REGULATED ENTY NAME THE RESERVE AT FAIR OAKS RANCH

PERMIT NUMBER: WQ0015219001

Subject: Army Request for Reconsideration on Proposed Permit NO. WQ0015219001

Subject: Army Comment on Proposed Permit NO. WQ0015219001; CN604516112
RN107104929

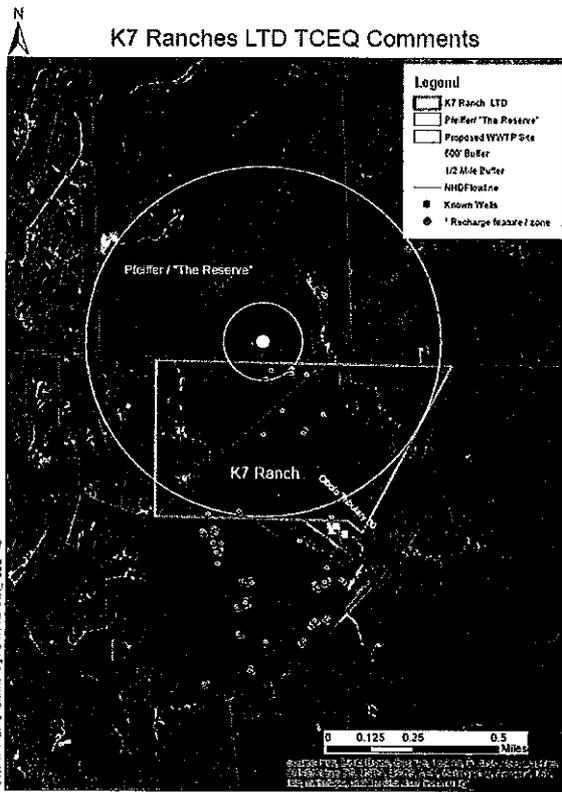
The first concern is related to water quality. The site for the package plant and wastewater irrigated greenbelt is in southeastern Kendall County. The site is also approximately 600 feet northwest of the Edwards Aquifer Contribution Zone, see map in my comment ltr at enclosure 1. The 40.5 acres proposed for land irrigation is more accurately described as karst surface and intermittent creek bed with potential for aquifer recharge. This package plant would be sited in a location that potentially is the boundary of the Upper and Lower Glen Rose formations. My understanding is that recharge features are frequently found along this boundary. See enclosure 2 of my comment ltr for excerpts from geologic reference materials. See also at enclosure 2 a photo taken August 26, 2014 by a local environmental consultant on the tract immediately to the south of the Reserve at Fair Oaks Ranch (aka Reserve at Ammann Road), known as the K-7 Ranch. The photo is of a large karst feature about 15 feet across. Of note, this feature is on the same channel that runs through the Reserve at Ammann Road site where the greenbelt irrigation area is located. The presence of karst features on the tract immediately to the south of the Reserve at Ammann Road is a strong indicator that there could be karst features on the site. I understand the owner of the K-7 Ranch submitted a detailed comment letter with maps/more photos and that several karst features have

been found, not just the one in the photo. The applicant should be required to hire a consultant to conduct a professional survey for cave or recharge features on the proposed site and the results reported to TCEQ. Then the wastewater permit writers at TCEQ should evaluate the results of such a study and evaluate the propriety of siting a wastewater plant and 40.5 acre irrigation system at this location.
